1110-Gen COE Engr & Des Corres Files- '85
Subject: Lake Pontchartrain LA & Vic. High Level Plan,
Hurricane Protection Pontchartrain Beach Floodwall

ENGINEERING DIVISION
Permit Review
Sheet

SUBJECT: Req by the University of New Orleans to Construct an Overflow Parking Lot on the Floodside of the N.O. Lakefront Hurricane Protection Levee/Floodwall and to Install Conduits Across the Levee/Floodwall, Vic. W/L Sta. 37+63, in Orleans Parish, LA.

SECTION AT LEVEE WALL

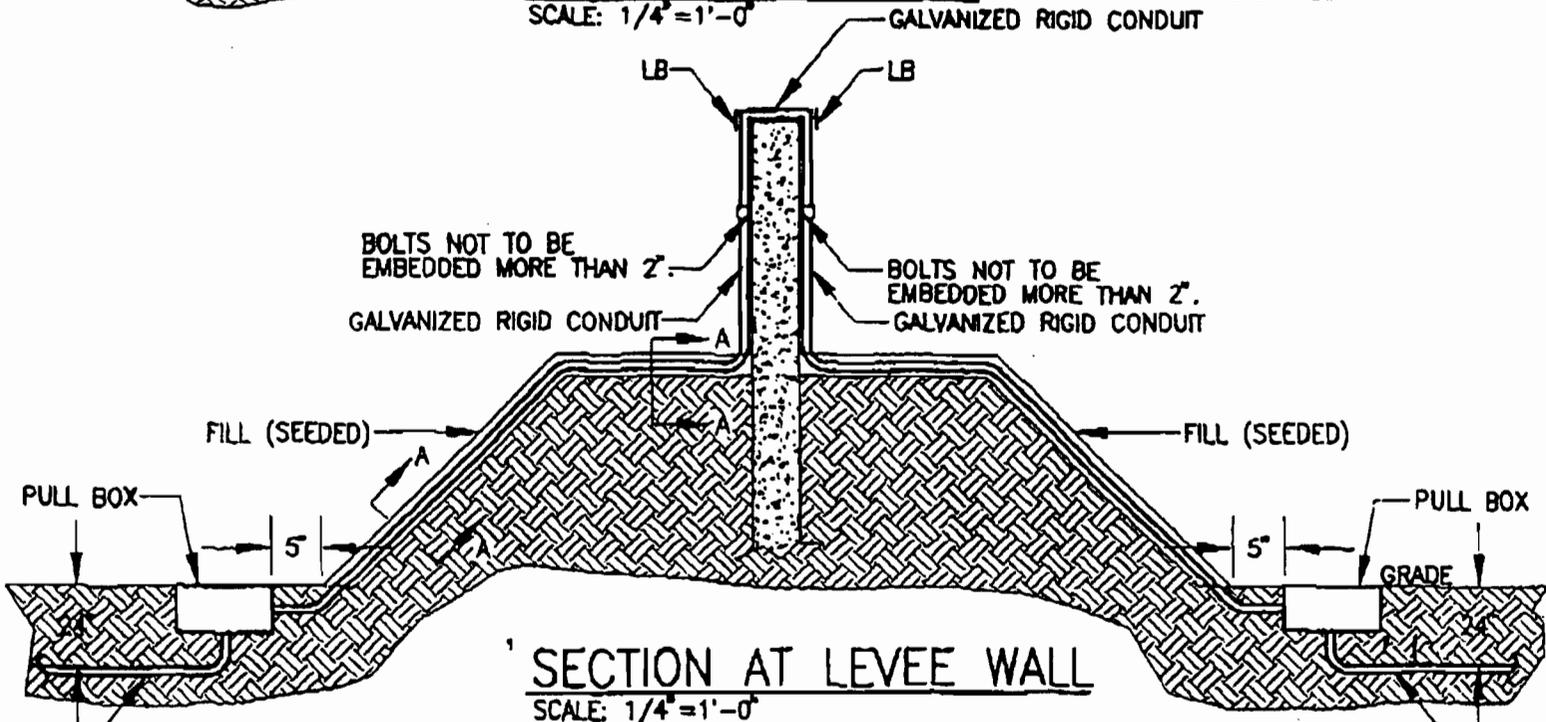
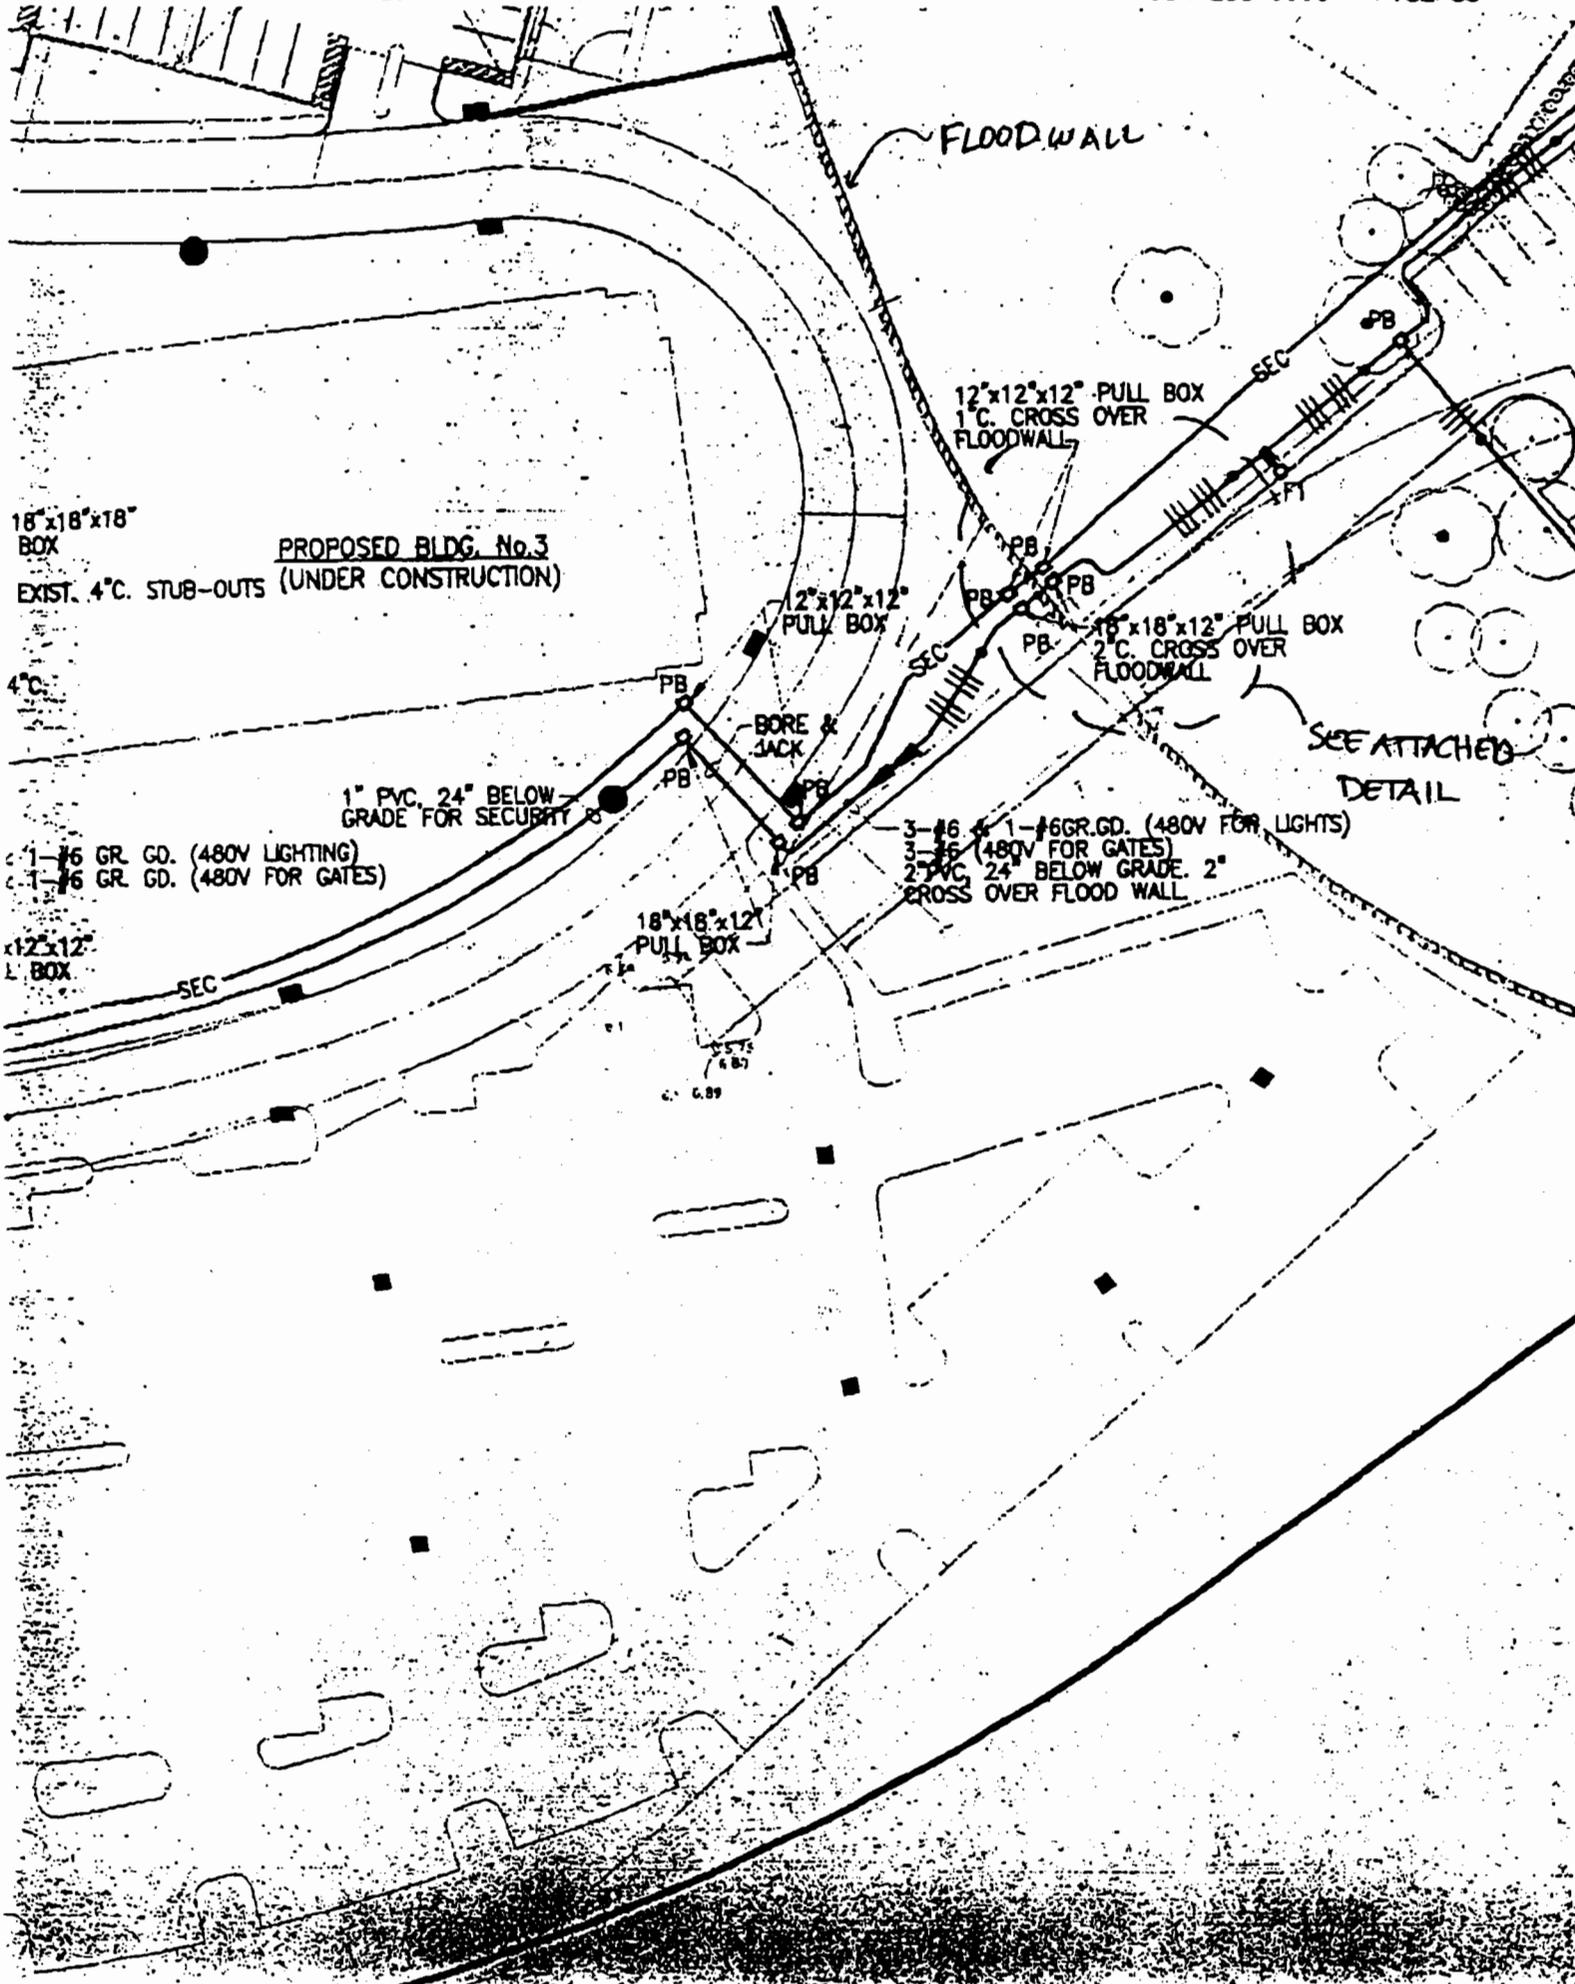
Re: Revised Conduit Detail
UNO Parking Garage – Overflow Lot

Mr. Keller, attached please find the proposed detail for conduit over the levee wall, revised per your comments. Please let us know if you require any additional information.
